TOWN OF FLOWER MOUND ENVIRONMENTAL CONSERVATION COMMISSION REGULAR MEETING

November 7, 2017

ITEM: Consider a recommendation to the Planning and Zoning Commission and Town Council of a Concept Plan for the proposed Serenity cluster development. The property is generally located south of FM 1171 and west of High Road.

EXHIBIT 6

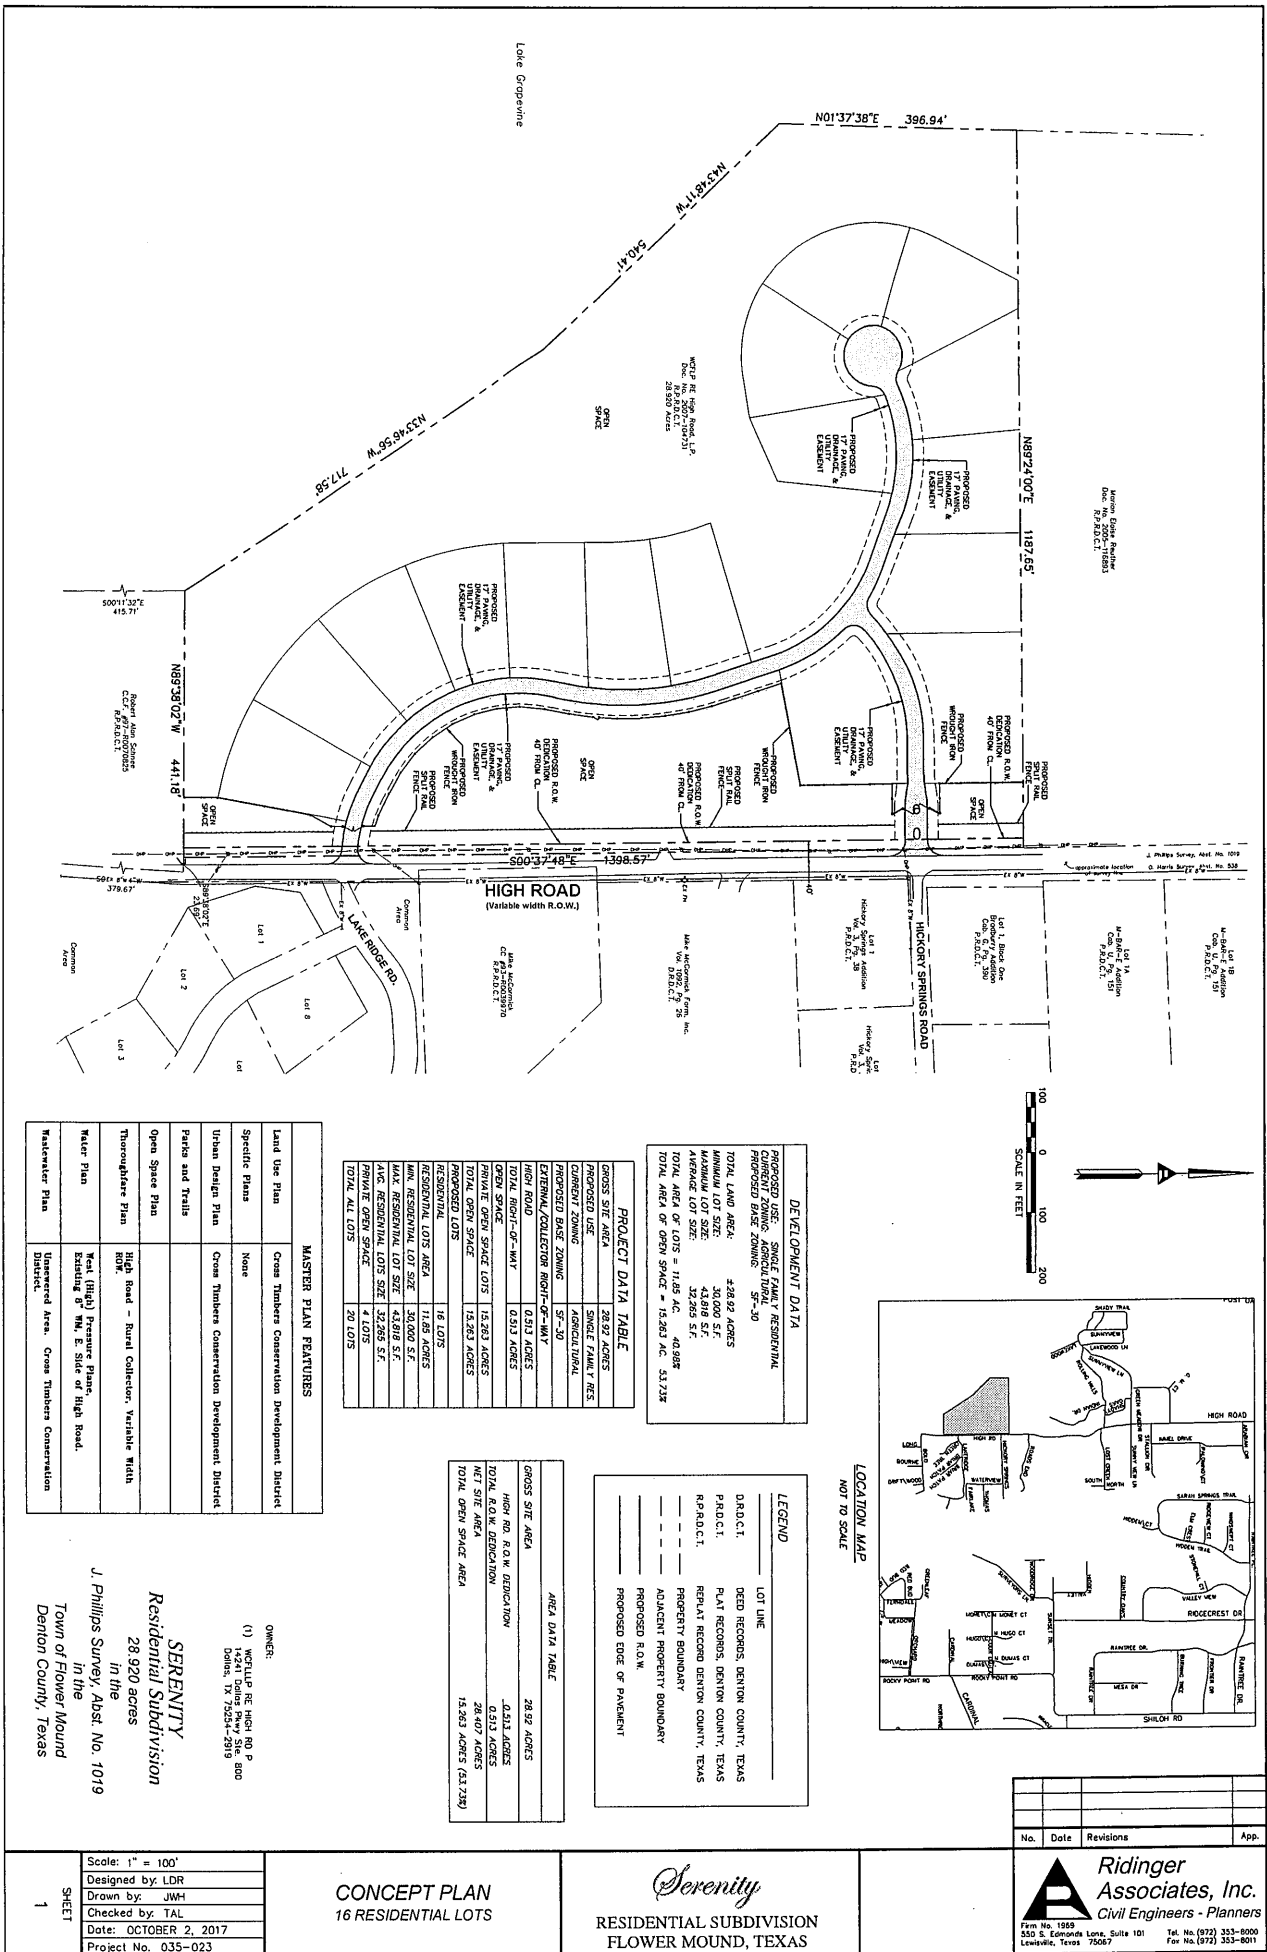
The Developer submitted a concept plan for the Development (the “Concept Plan”) to the Town, and a true and correct copy of said Concept Plan is attached hereto as “Exhibit 6,” and is incorporated by reference as if fully set forth herein. Because the Concept Plan does not provide the lot sizes, and therefore, it is impossible to make a determination regarding the amount of variance exists between each of the sixteen (16) lots. However, it seems apparent the lots are fairly close in size.

The Concept Plan shows the sixteen (16) lots are not placed outside of the view area. Seven (7) lots on the north side of the Property and at least two (2) lots on the south side of the Property will provide views into the backyards of the houses from High Road. While the houses are situated across from a small partition of “open space,” the vast majority of the “open space” is situated behind the sixteen (16) lots and will not be visible from the Scenic Corridor of High Road, and only a two of the eight (8) lots on the north of the Development face High Road. *See* Exhibit 6 – Concept Plan. The Development does not place the new houses outside the view area of High Road, a majority of the houses do not face High Road, about half of the houses will provide views into the backyards of the houses, and the open space which is being conserved will not be viewable from High Road.

Additionally, the Urban Design Plan states house lots should be grouped and dispersed to minimize linear relationships visible inside the scenic corridor. *See* Exhibit 8, pg. 4.41. The Concept Plan demonstrates the Development essentially is comprised of two groupings of eight (8) and seven (7) houses. *See* Exhibit 6. At the north end of the Development, it cannot be argued that at least five (5) lots are linear in relationship to each other. Towards the middle of the Development and leading to the south end of the Development, all seven (7) lots have a linear relationship.

EXHIBIT 7

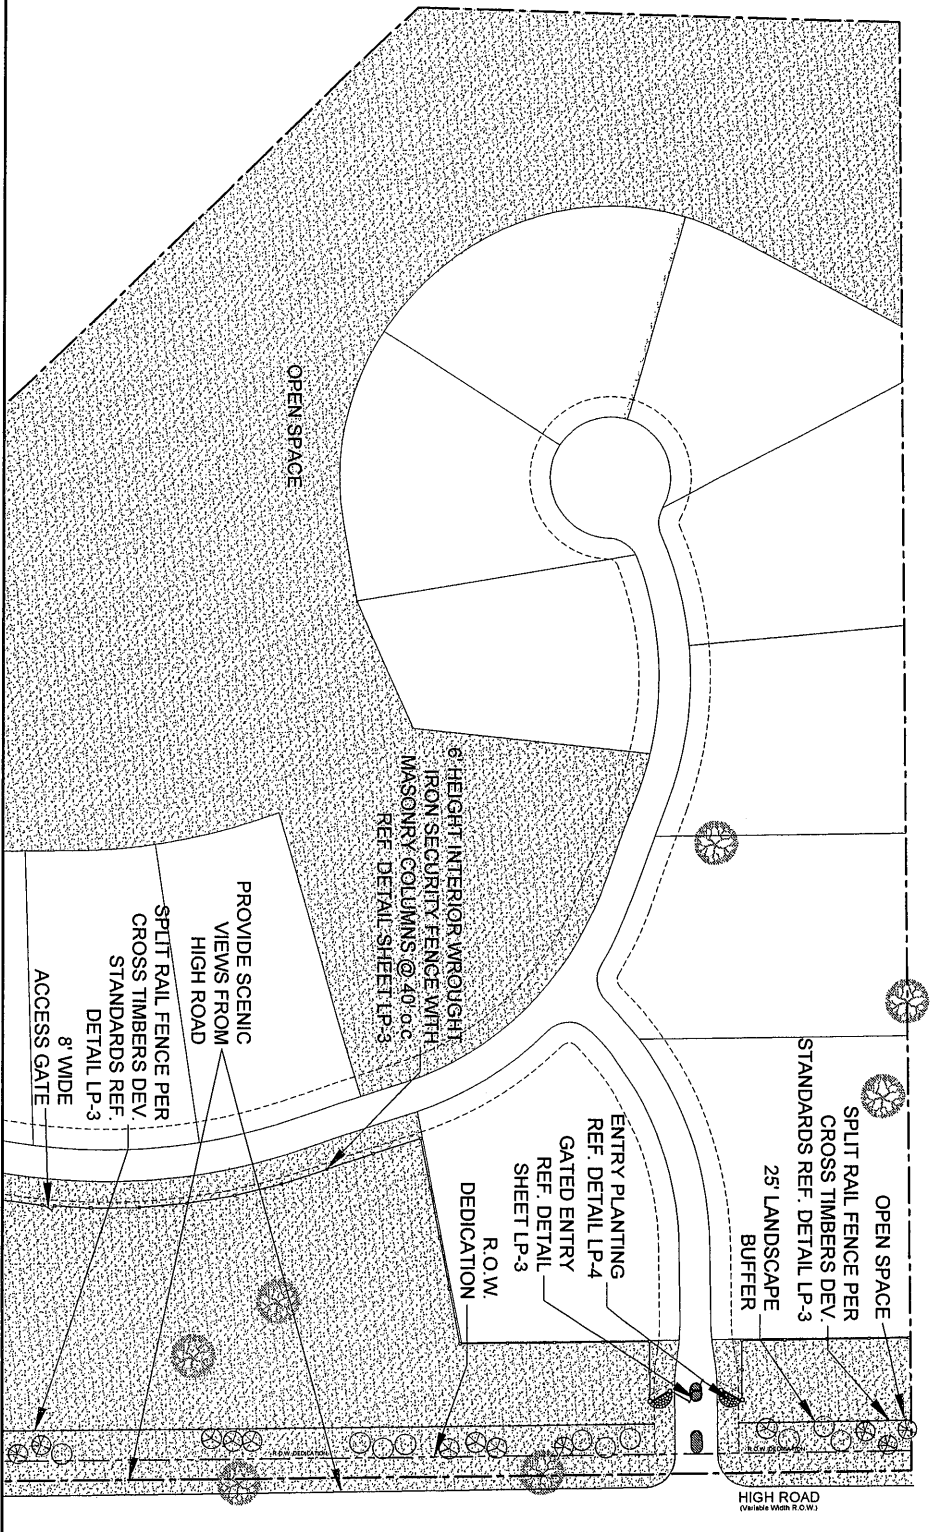
Additionally, according to the Developer’s landscape plans (the “Landscape Plans”), the Development will be a gated community surrounded by a wrought iron fence between masonry columns as well as a split rail fence. A true and correct copy of said Landscape Plans is attached hereto as “Exhibit 7,” and is incorporated by reference herein. *See Exhibit 7*. None of the properties adjacent to the Development are gated communities. The transition from a lot to the north with a large quantity of pasture to gated community (the Development) and then back to a lot with a large quantity of pasture to the south does not provide for an appropriate transition required by the CTCD Area Plan. Moreover, the wrought iron fence is not consistent with the requirements for a standard rural fence as set forth in the Urban Design Plan (the “Urban Design Plan”). A true and correct copy of the pertinent portions of the Urban Design Plan are attached hereto as “Exhibit
